Service Information Bulletins

1997

GRUNDIG
made for you

Product: TV's with Digi Basic chassis

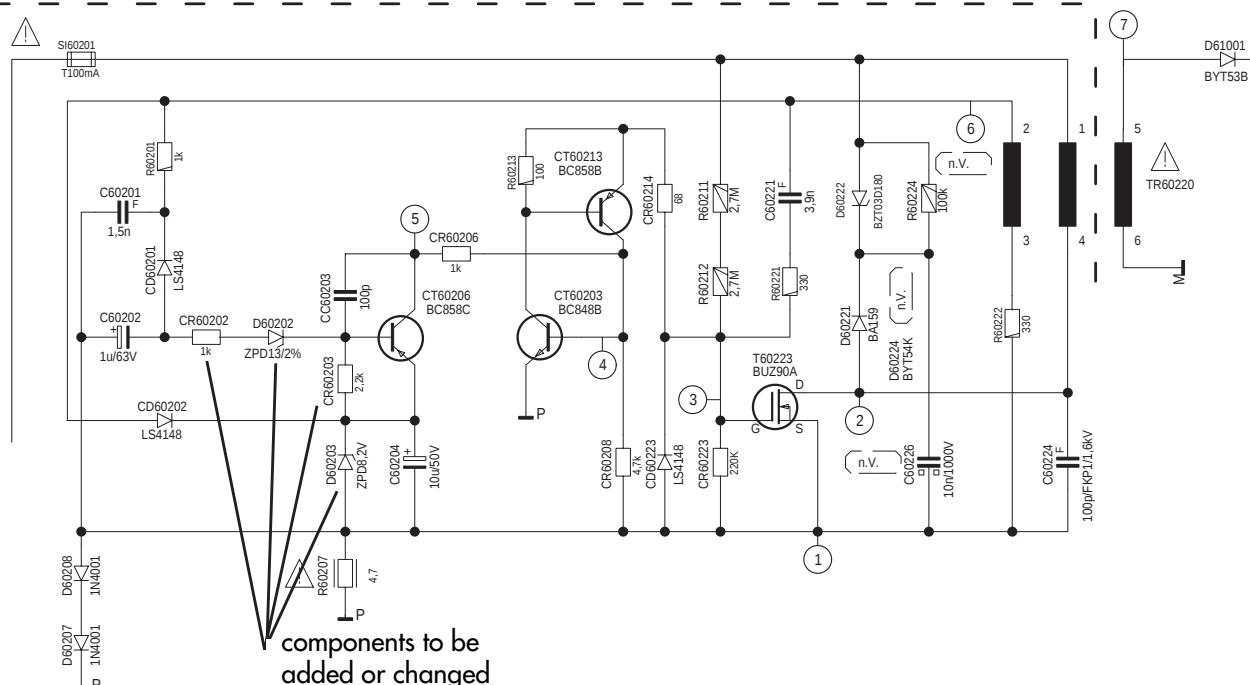
Brown colouration of the circuit board near the diode D 60222 BZT 03D180. Simultaneously the "+Eco" voltage is approx. 5V too high.

Coincidence of unfavourable component tolerances.

Carry out the following changes in the stand-by mains stage:

- Change the Z-diode D 60203 from ZPD 9.1V to 8.2V.
- Change R 60202 from 68 k Ω to 1 k Ω .
- Connect an additional Z-diode ZPD 13 in series with R 60202. Connect the cathode of the diode to the base of the transistor CT 60206.
- Check the rating of the resistor CR 60203 to be 2.2 k Ω .

Product: TVR 3701 SV

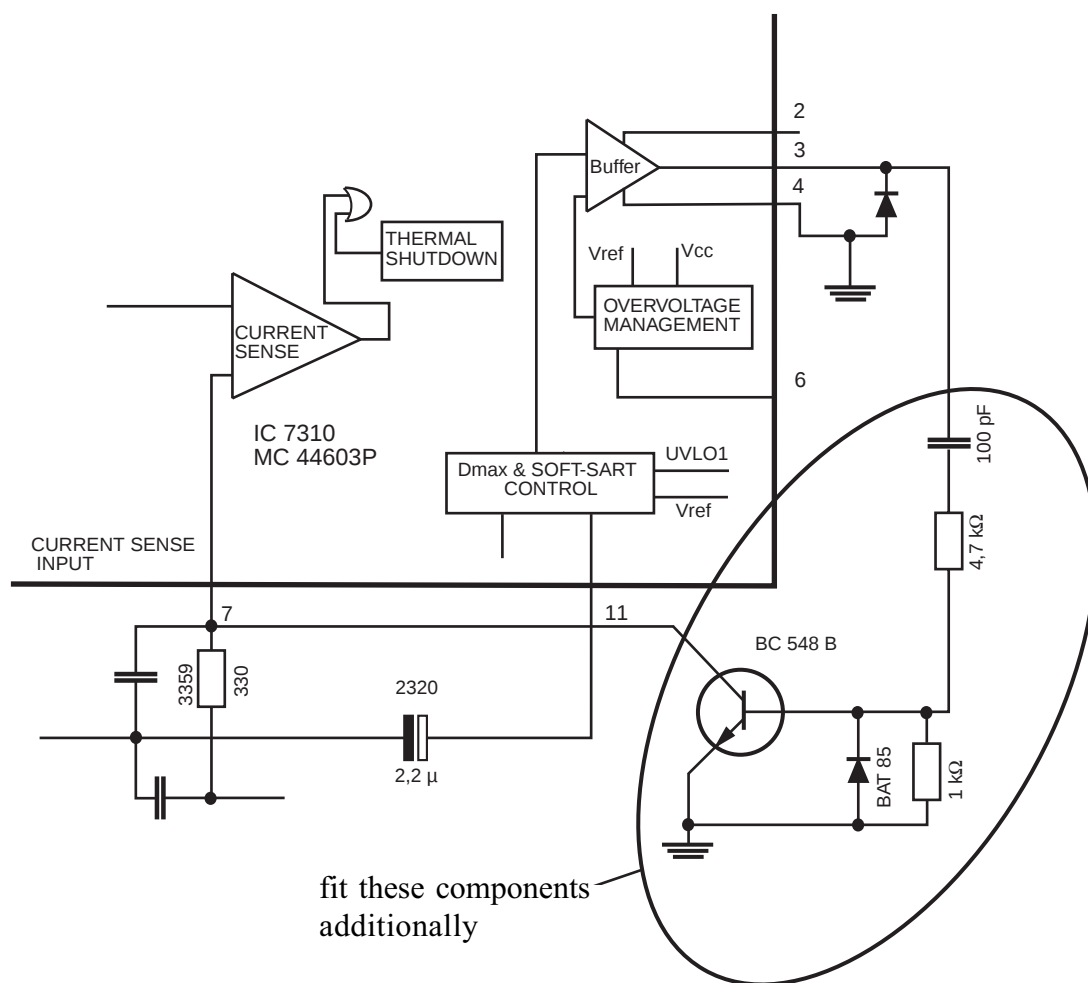
Mains voltage dependent chirp audible in stand-by mode.

Fit an additional transistor stage as shown below into the power supply unit at IC 7310 (MC 44603 P).

Product: CUC 7301

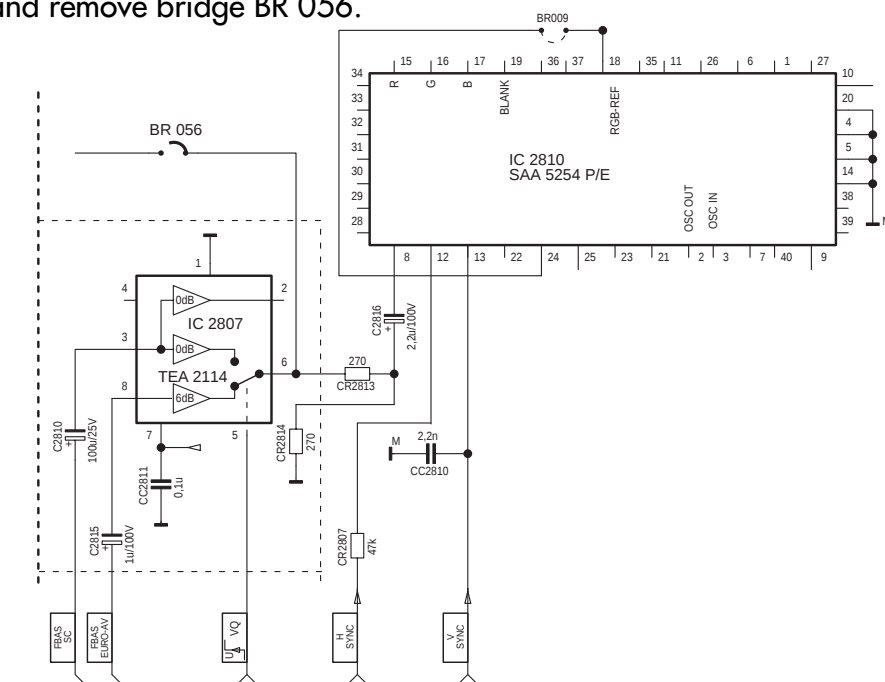
Teletext operation is not possible in "AV" programme position.

The video switch-IC 2807 (TEA 2114) is not fitted in 37 cm television receivers.

Retrofit the following components:

In addition, change the polarity of 2.2 μ F electrolytic capacitor C 2816 (negative terminal to pin 8 of IC 2810) and remove bridge BR 056.

Product **Colour television receivers with chassis CUC 7350, e.g. ST 55-750 text**

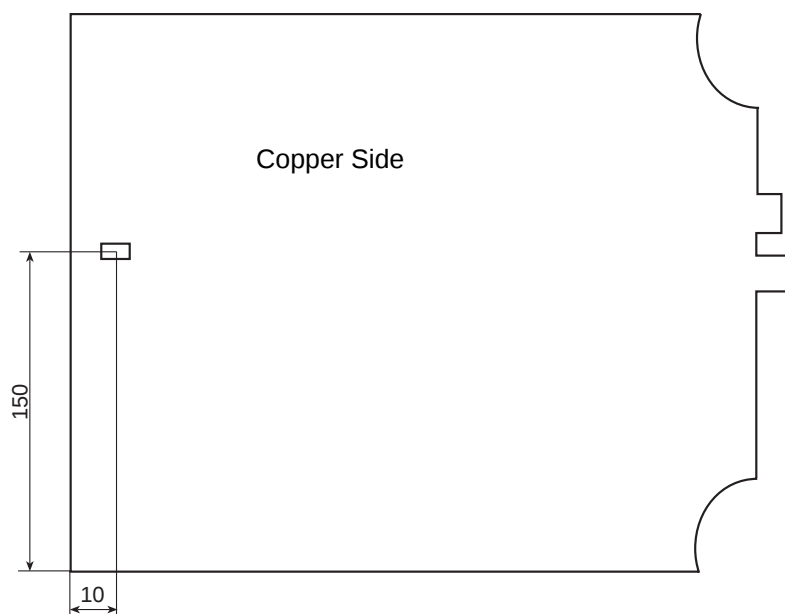
Temperature drift of the +E operating voltage by about 0.2 to 0.3V caused by Z-diode CD 61023. Consequently, IC 34015 TDA 8374 switches off with sudden black/white changes in the picture content or changing scenes.

This Z-diode has been introduced later and therefore is drawn in only in the 1st Supplement to the CUC 7350 Service Manual.

The position of the Z-diode is X=10, Y=150. Unsolder this diode and insert a SMD resistor 1206 1.2Ω 1% in this place.

Product Colour television receivers with chassis CUC 7300, e.g. P 37-740 SAT, and all sets retrofitted with the built-in satellite receiver SER 7300

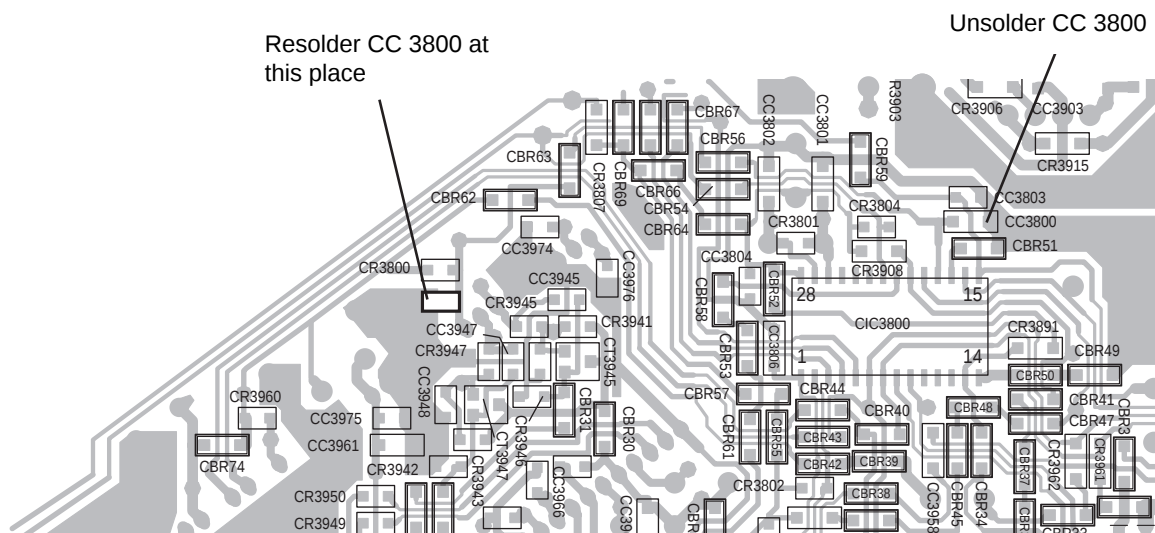
The sound disappears suddenly during the reception of a satellite programme and is audible again only when changing the programme or switching the TV off and on again.

IC MSP 3400 on the SAT Module hangs up by static charges entering the Reset input of the IC.

Unsolder the SMD capacitor CC 3800 from its place on the SAT Module and resolder it at the place indicated on the figure below.

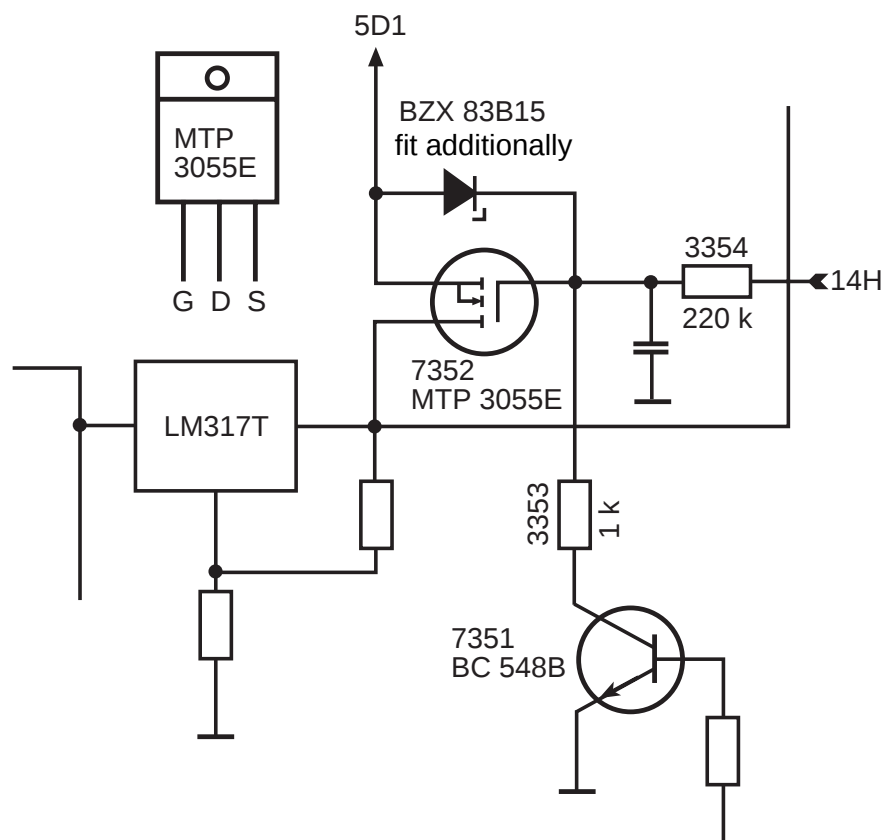
TV Recorder does not operate.

Defect in transistor 7352 (MTP 3055E) caused by static discharges in the TV Recorder.

Fit an additional Z-diode BZX 83B15 between gate and source to suppress voltage peaks at the gate.

The Z-diode must strictly be retrofitted if the transistor 7352 fails. This change is carried out already in the factory.

Product Colour television receivers with chassis CUC 7303/7305/7350 and the picture tube panels 29305-022.16/-022.17, e.g. P 37-731 text, P 45-731 text, T 55-731 text, P 37-731/12 text, ST 55-750 text, XS 55/1, Lissabon SE 5576 text

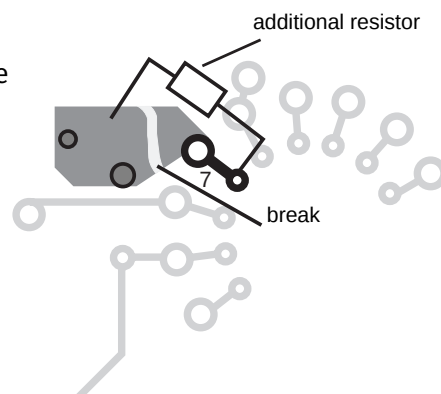
Failure of the RGB output stages (picture tube panels 29305-022.16 and -022.17) or of the teletext function.

The semiconductors are destroyed by high-voltage sparks within the picture tube.

On the picture tube panels -022.16/-022.17, insert an additional 1.5 k Ω composite carbon resistor (do not use a carbon film resistor!) into the circuit path to the screen grid connection of the picture tube socket. Ensure that the break is 2mm wide at least (see figure) to avoid sparking.

Product **Colour television receivers with Digi 6 chassis CUC 1842, 1894, 1952, 1962 and 1983, e.g. M 72-410 Ref., Denver SE 8216/9 PAL Plus, M 70-269/9 Ref.**

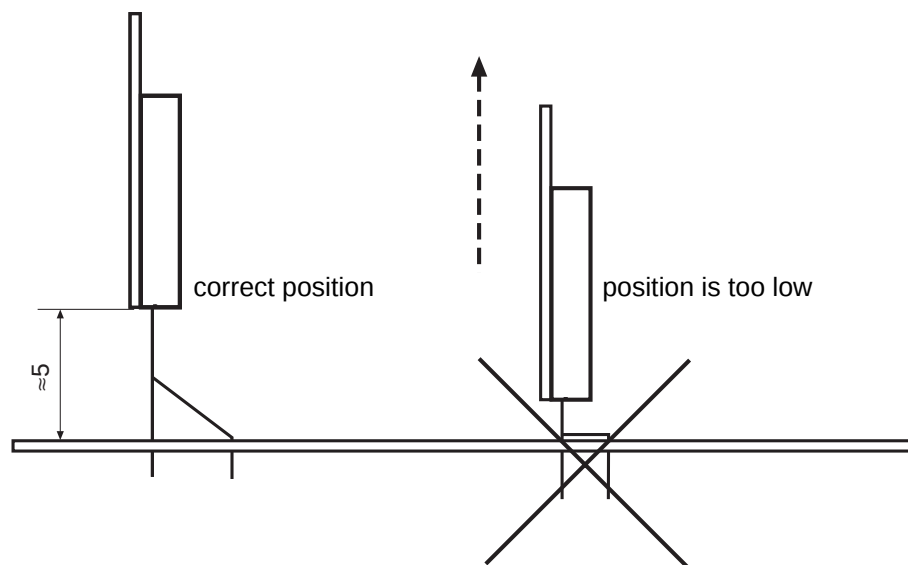
Vertical output stage TDA 4173 fails or thin white lines similar to retrace stripes are visible.

Inherent instability of the vertical output stage IC TDA 4173 AF.

- Should above mentioned symptoms appear do not fail to exchange TDA 4173 AF and solder additionally a 1 nF foil capacitor from pin 1 and from pin 7 each to pin 4 (-K voltage) on the copper side.
- Check the mounting position of the vertical output-IC. If the position of the IC is too low, the pins may temporarily come into contact with the chassis connection on the upper side causing the IC to fail. Additionally, the circuit may already be damaged by the building up force of pressure resulting in a long-term failure. Therefore replace TDA 4173 AF also if it has not been fitted correctly!

Product Colour television receivers with Digi Basic chassis - CUC 1806, 1825, 1826, 1827, 1829, 1830 with the picture tube panels 29305-122.04/-122.10/-122.12 and -122.17
e.g. ST 70-255 IDTV/LOG, ST 72-261 IDTV/LOG, Atlanta SE 7220 IDTV/LOG, ST 72-261 IDTV/LOG

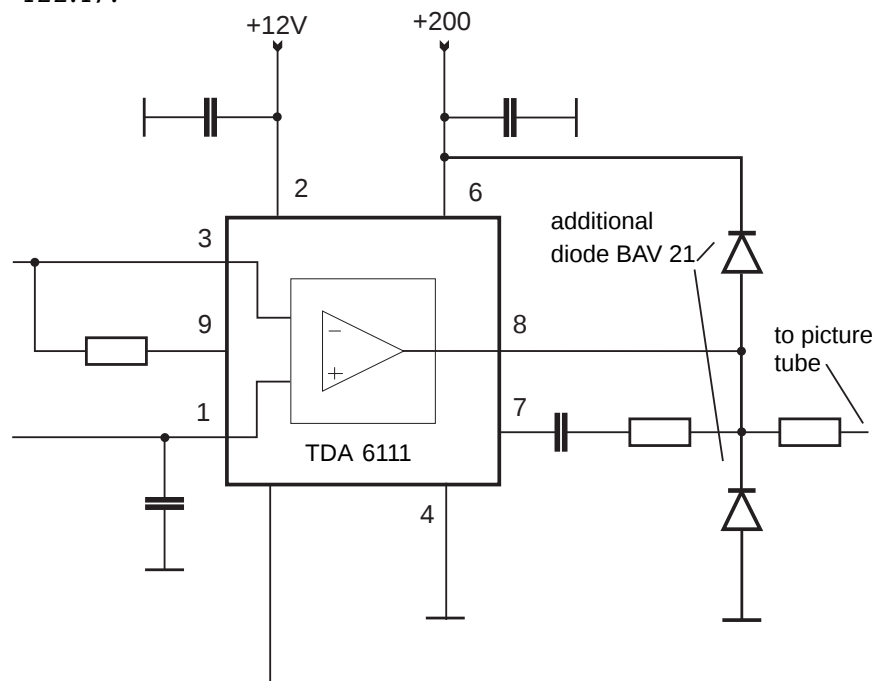
Failure of the RGB output IC's TDA 6111.

The RGB output IC's are destroyed by high voltage sparks.

Directly from the outputs (pin 8) of the three output IC's TDA 6111 connect one additional diode BAV 21 each to chassis and one diode each to the +200 voltage (see figure).

The insertion of the three diodes which are to be connected to +200 is already prepared on the picture tube panel by the diodes D 734, D 754 and D 774.

The three diodes which are to be connected to chassis are to be soldered on to the copper side from pin 8 to pin 4 (anode to pin 4).

Product **Series GV 4xx video recorders with „World Deck“**

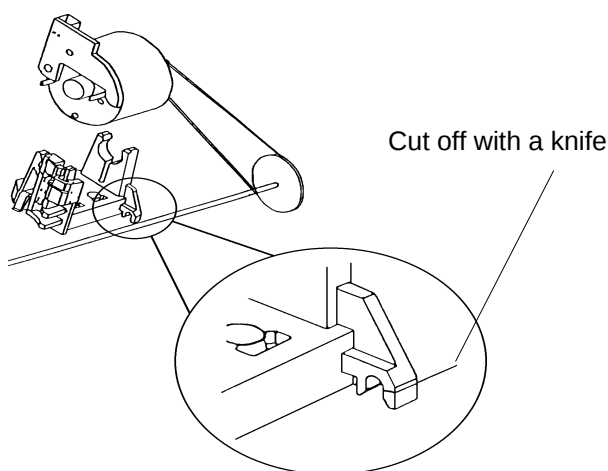
Drive mechanism does not move.

Slipping of the bevel gear of the pulley shaft (pos. 47) and / or worm shaft (pos. 48).

Replace the pulley shaft and / or worm shaft.

To replace the pulley shaft quickly follow the instructions given below:
Dismantle the drive mechanism, set the drive mechanism to EJECT position, remove the cassette compartment, remove the threading belt, detach the worm shaft and the pulley shaft,

cut the motor holder with a knife as shown on the figure below,
pull out the pulley shaft, fit and snap in the new pulley shaft and worm shaft, refit the cassette compartment as described in the Service Manual.

Product **GV 660 / GV 690**

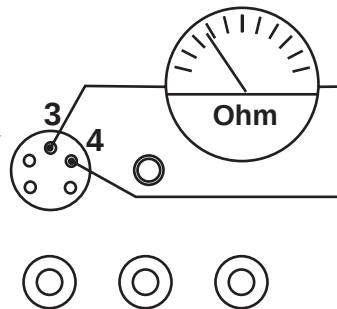
Master/Slave and Synchro Edit control functions do not work.

In a small number of GV 660 and GV 690 video recorders, the 7-pin cable (pos. 9511) from the keyboard control unit to the teletext module is not inserted correctly (laterally inverted) on the keyboard control unit.

Disconnect the 7-pin cable from connector 1511 on the teletext module, turn it by 180 degrees and refit it.

Chassis Board - Head Amplifier

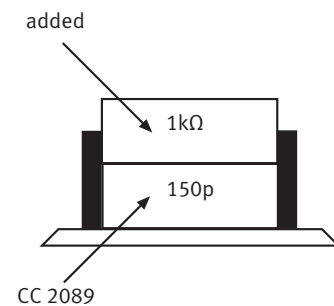
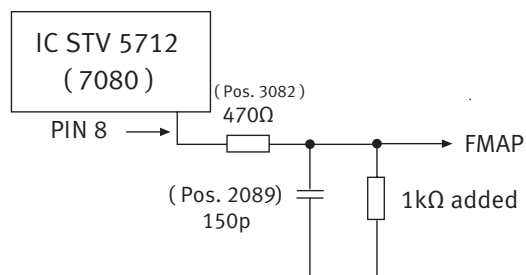
Disturbances and noise along with the HIFI sound.

No steady audio-FM signal identified on playing back.

Carry out the following changes on the chassis board - head amplifier.

1. Change CR 3082 from 100Ω to 470Ω.
2. Change CC 2089 from 220p to 150p.
3. Add CR 1kΩ to CC2089.
